Administrative Review

Date: November 27, 2020
To: Jason Plourde, Chair, Zoning Board of Adjustment
From: Lincoln Daley, Community Development Director
Subject: **Case #2020-31:** Meridian Land Services, Inc. for the property located at Milford Tax 56, Lot 52-2 – Special Exception Application

LUMBAR DRIVEWAY
 OVERALL SITE PLAN

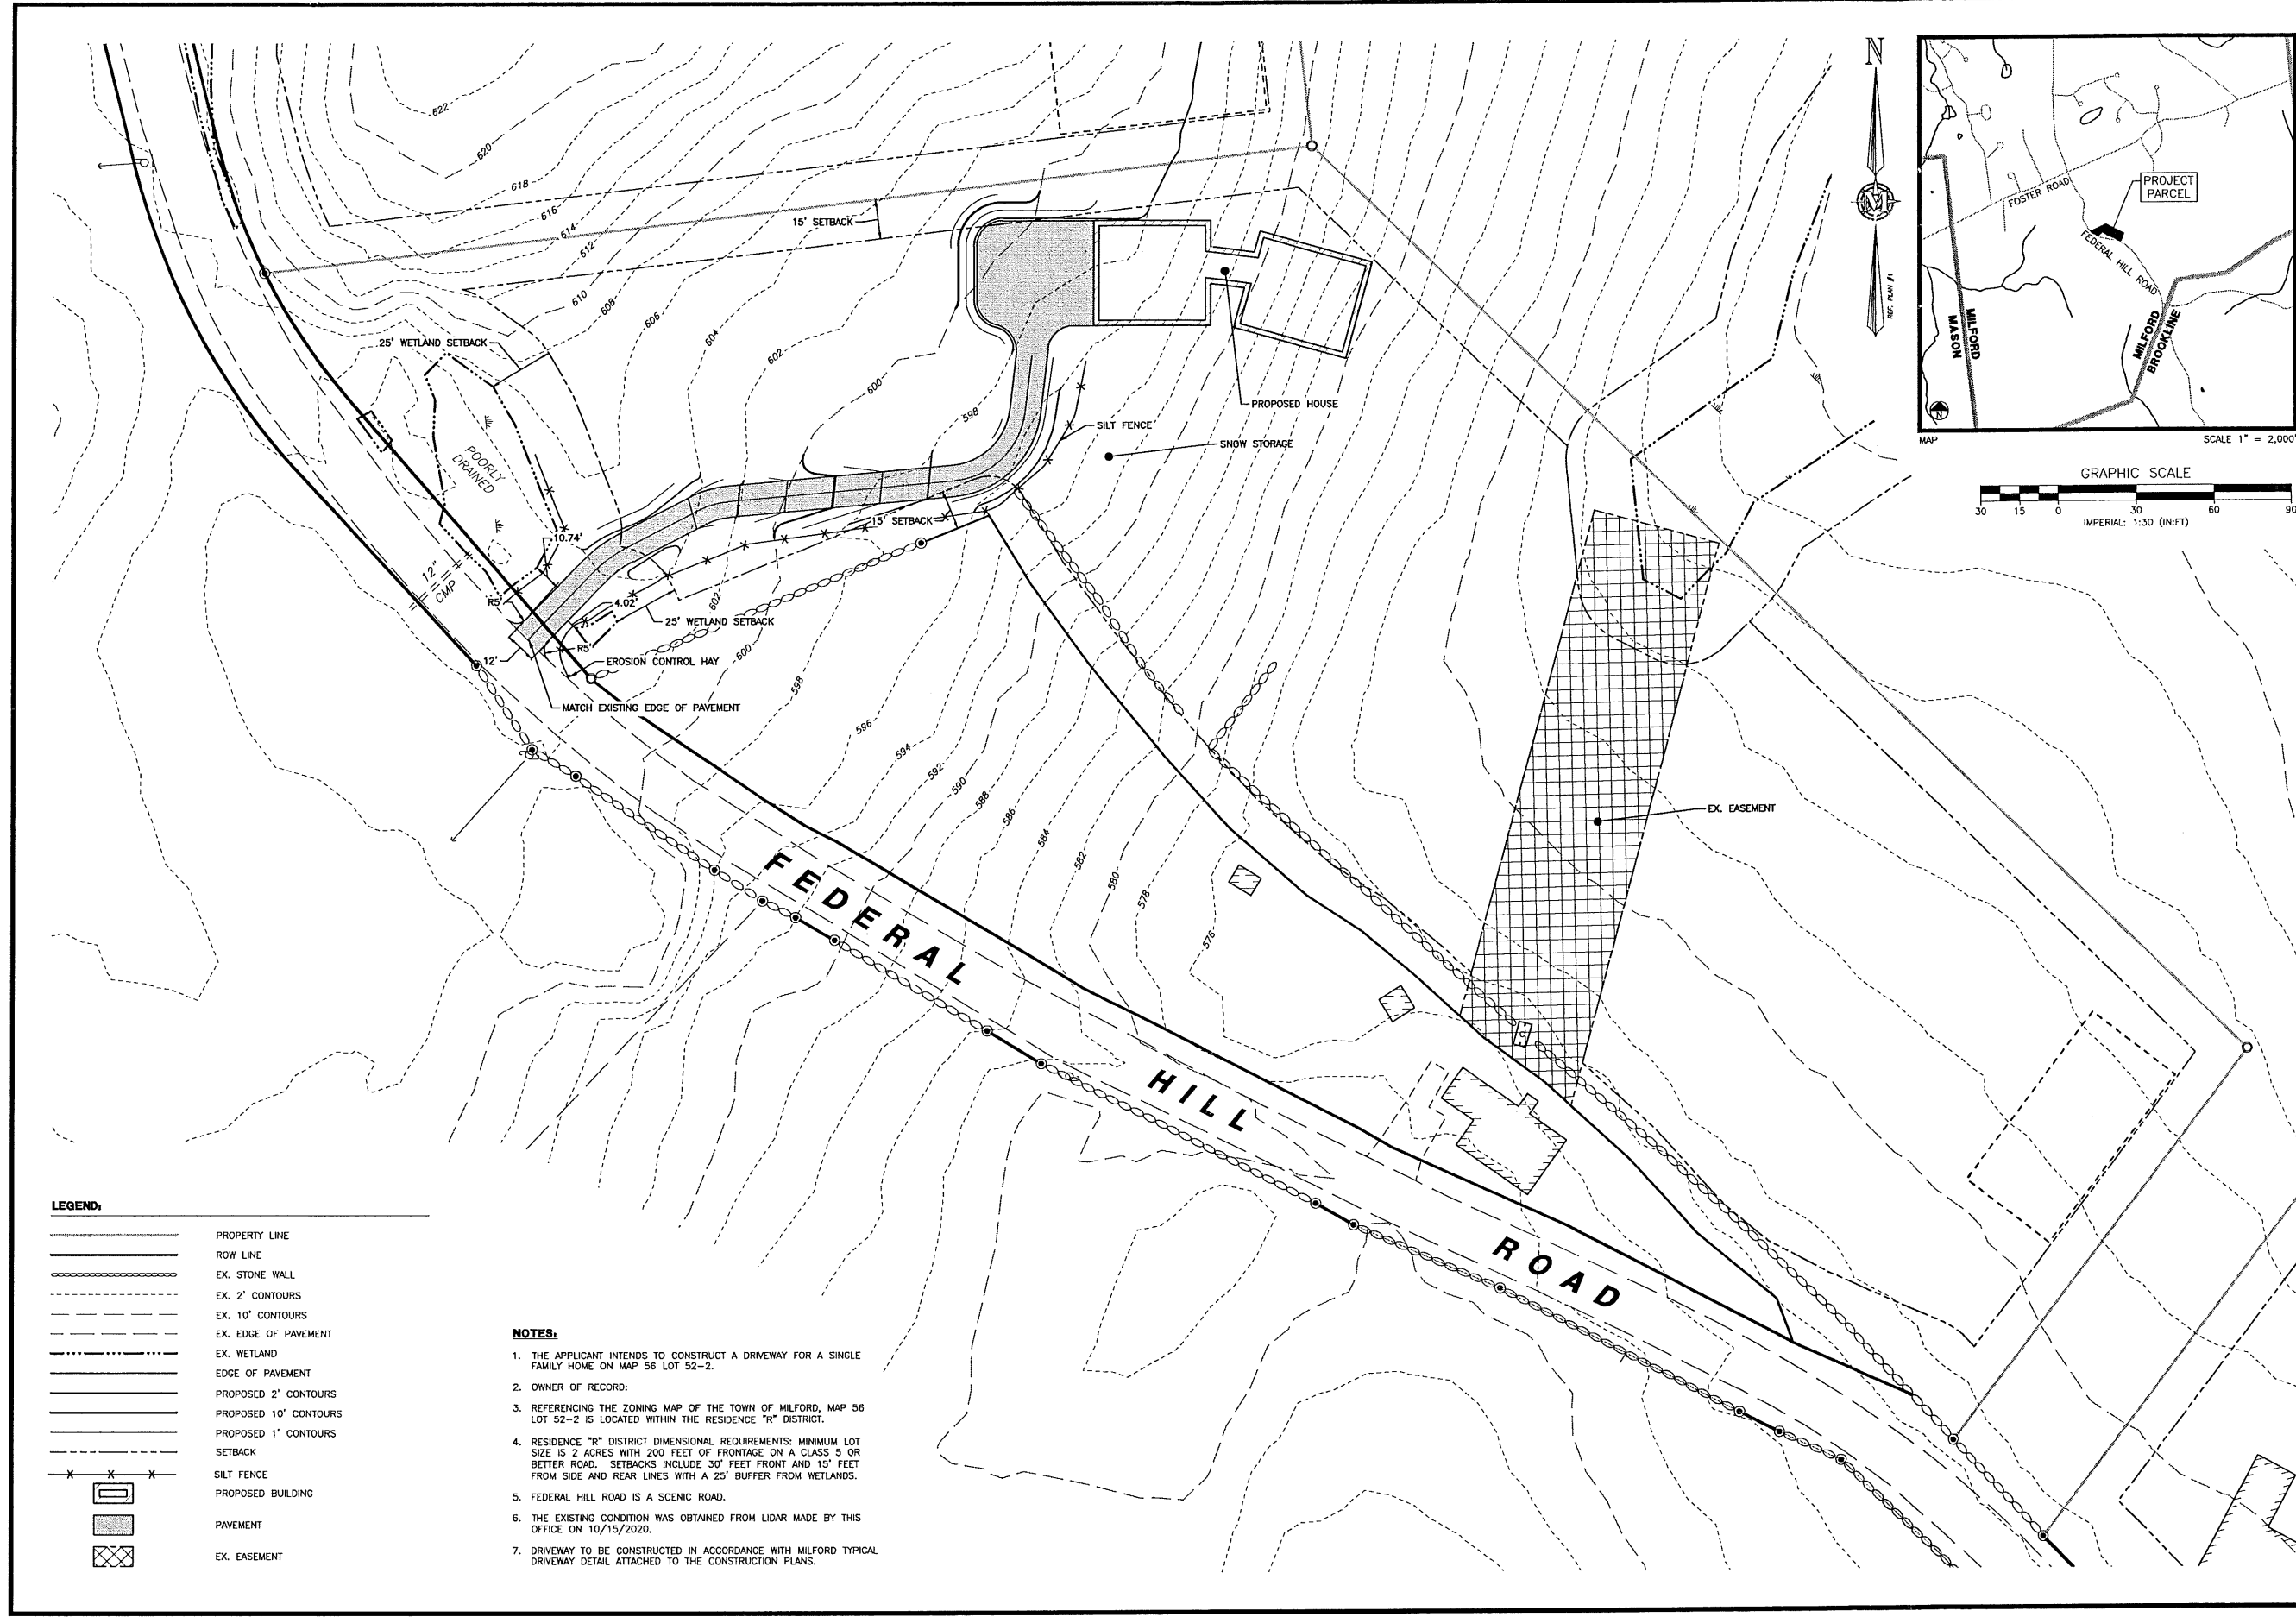
2. The proposal calls for the construction of a 650 foot long by 12 foot wide driveway on the southwestern portion of the property off of Federal Hill Road to service a single-family residence. The construction of the driveway will impact approximately 1,150 square feet of delineated wetland buffer area, but will not encroach within the wetland resource area.

3. The site contains an existing easement that bisects the lots and two wetland areas along its frontage. The location of these pre-existing features limits the location of a compliant driveway to the proposed location. The applicant has consulted with and received approval from the Public Works Department to locate the proposed driveway.
